project
 1 SPRING STREET, MELBOURNE

Milton House, Melbourne Planning Application

A new 35-storey (excluding 3 plant levels) commercial office building, with an overall height of RL188.600 (measuring 160.88 metres above a spot level of RL27.72 at the centre of the site's Flinders Lane frontage, and 170.1 metres above a spot level of 18.5 at the centre of the site's Flinders Street frontage).

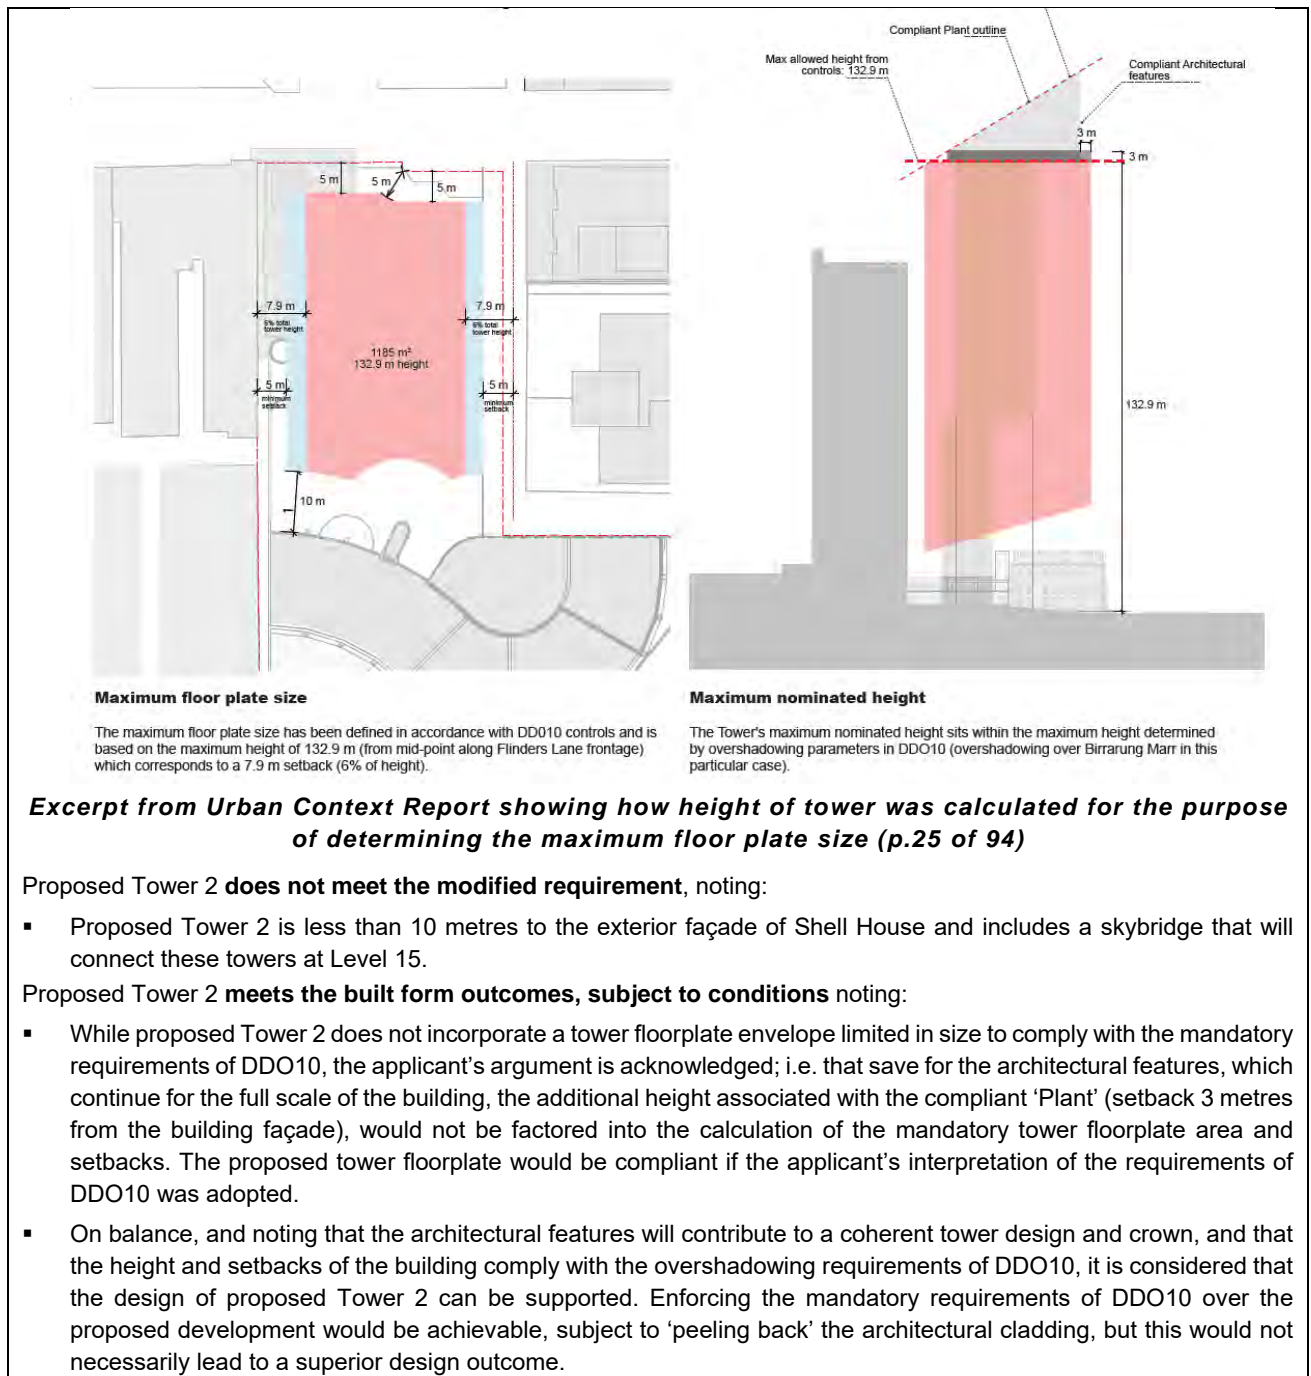
The Urban Context Report appears to adopt a maximum height of 132.9 metres for the purpose of determining the minimum setback (nominated as 7.9 metres), carving approximately 30 metres off the ‘total building height’. This 30 metre section of the building has been labelled as ‘Compliant architectural features’.

While the plant indicated inside the excess levels is setback 3.0 metres and can be considered compliant, the architectural features, being the extended and sloped tower façade referred to in the below diagram exceed 3.0 metres in height. This is therefore non-compliant and it is appropriate to include this section of the tower when calculating the ‘total building height’.
